# Accessibility audits of sites within the Causeway Coast and Glens Heritage Trust area

Improving access for disabled residents and visitors

Prepared by Direct Access Consultancy Limited  
Summer 2021

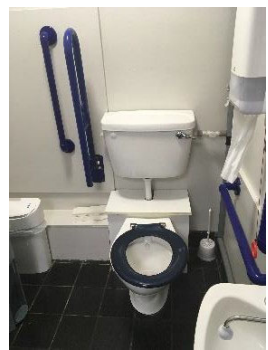
152.	Dunluce Castle / Surfacing		Cobbled surfaces are not considered accessible for disabled people.	Subject to heritage considerations consideration should be given to providing a 1200mm width smooth, level and slip-resistant surface underfoot.	3	C

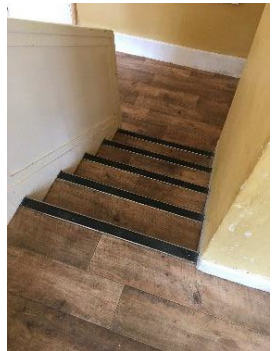
227.	Cushendun / Village / Riverside Walk / Seating		Seating provided is not to an accessible standard and is located in areas that are not accessible to some disabled people.	<p>1) There should be a variety of seat heights, ranging from 380 mm to 580 mm, within which a height of 480 mm is suitable for wheelchair users.</p> <p>2) Armrests should be provided to help people lower themselves onto the seat and stand up.</p> <p>3) Where the seat is set at a height suitable for wheelchair users, armrests should not be set in so as not to restrict the lateral transfer from a wheelchair</p> <p>4) A supportive back-rest should be incorporated for at least 50% of the length of the seat.</p>	2	B

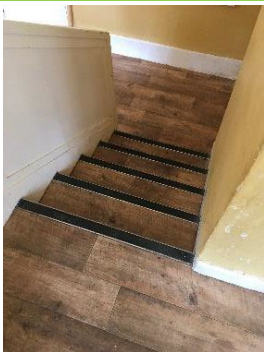
229.	Glenmona House / Accessible Entrance / Signage		When looking at the front of the house it is not clear where the accessible entrance is.	<p>Signage indicating the location of any alternative accessible entrance should be clearly visible on the approach to the building.</p> 	1	A

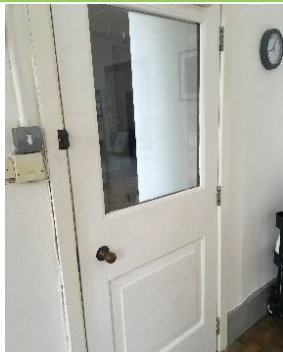
236.	Glenmona House / Entrance / Doorbell		The doorbell is located too high for wheelchair users or people of short stature to reach. The white of the doorbell does not provide sufficient contrast with the window frame.	The doorbell/call button should be contrasted against its background and relocated at a height of between 900mm and 1100mm.	2	A
